WASHINGTON STATE
DEPARTMENT OF TRANSPORTATION
CHANGE ORDER

CONTRACT NO: 009157 FEDERAL AID NO:
CONTRACT TITLE: I-5, PORTLAND AVENUE TO PORT OF TACOMA ROAD - SOUT
CHANGE ORDER NO: 27 MCKINLEY/D ST & PACIFIC S.W.

CHANGE ORDER NO: 27

This Change Order adds Work to design and construct maximum extent feasible ADA compliant pedestrian facilities, including the implementation of traffic control, in three quadrants of the McKinley Way and D Street intersection and one area on the Pacific Ave and S 32nd Street intersection.

McKINLEY BRIDGE - PAVING DETAIL

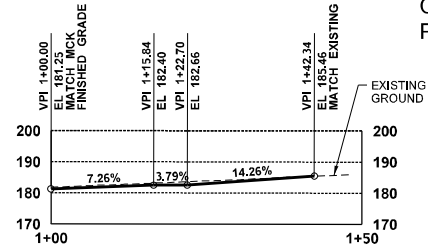
- On the east quadrant, repair ADA ramp and all sidewalk from approx. Sta. MCK 17+08 to MCK 18+27. Grind grade breaks to 1/4 inch to flush or bevel to 2:1 at curb and gutter section at ADA ramp.
- On the west quadrant, repair ADA ramp landing.
- On the south quadrant, repair southwest ADA ramp and two sections of sidewalk from approx. Sta. MCK 17+44 (38' RT) to 17+70 and MCK 17+75 to 18+26. Grind grade breaks to 1/4 inch to flush or bevel to 2:1 at curb and gutter section at southwest ADA ramp.
- Released for Construction traffic control plan sheets, TC49-01, TC49-02, TC49-03, TC49-04, TC49-05 and pages 4 through 8 of this Change Order.

PACIFIC AVE BRIDGE - PAVING DETAILS

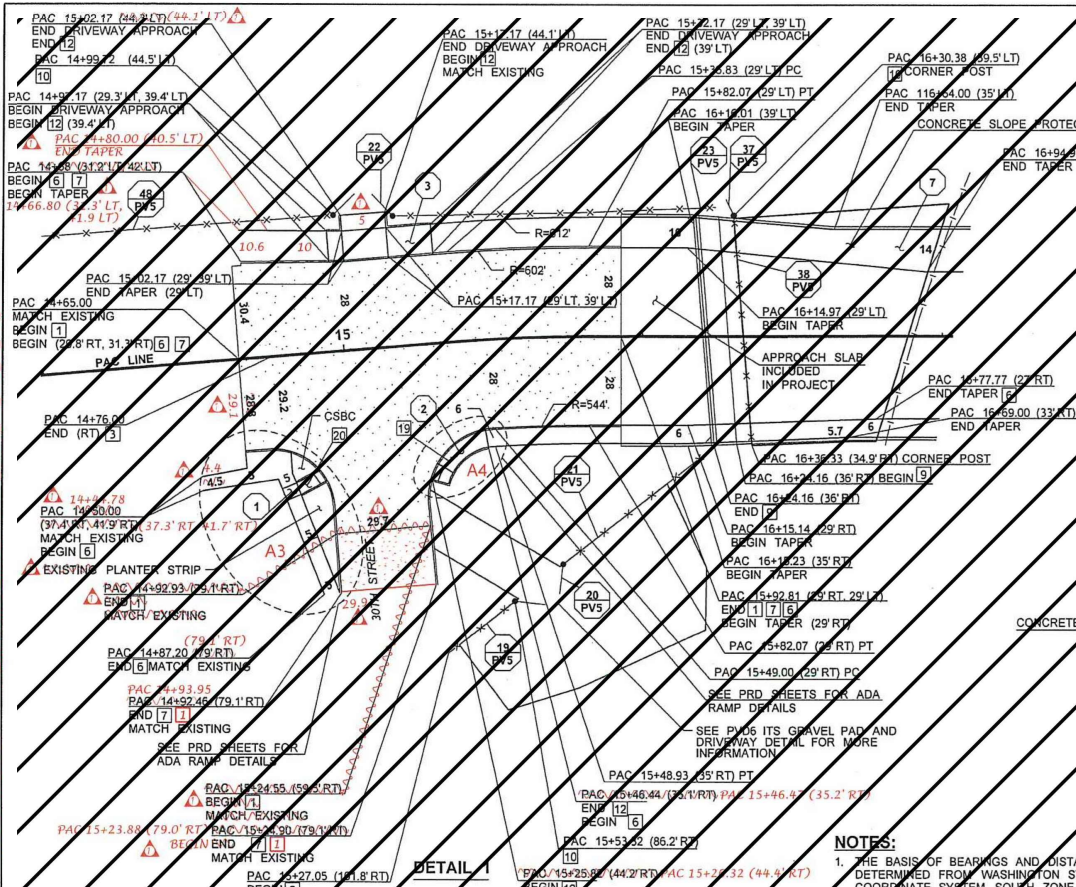
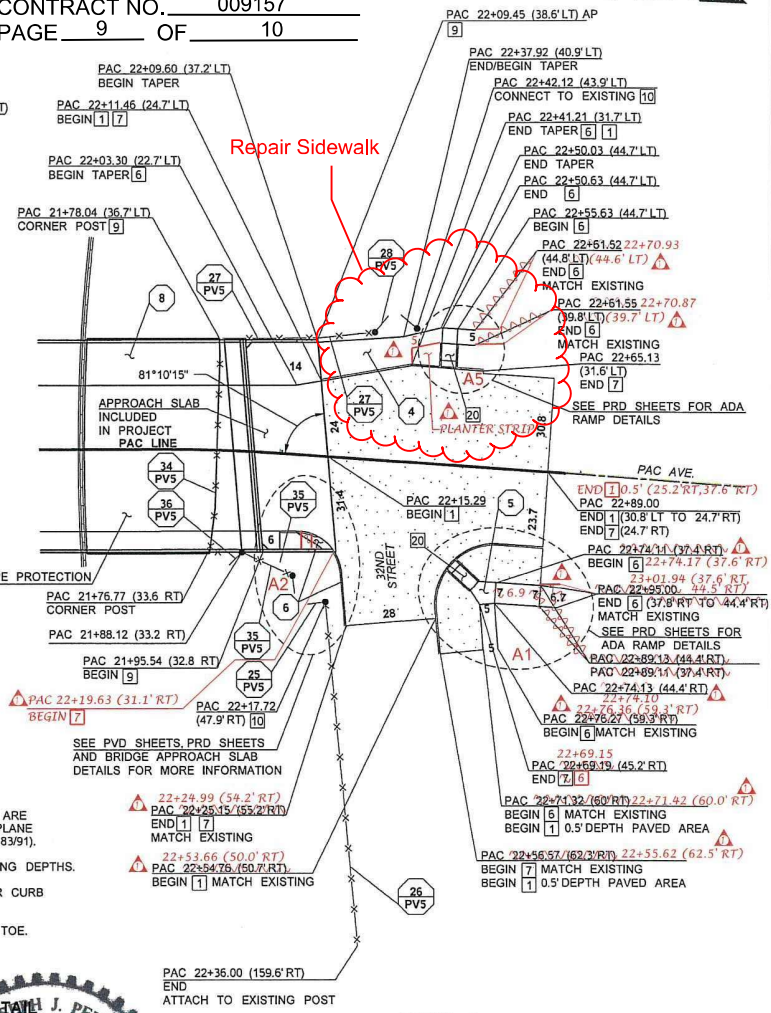
- On the east quadrant, repair sidewalk around the planter strip.
- Released for Construction traffic control plans sheet TC48-02 and pages 9 and 10 of this Change Order.
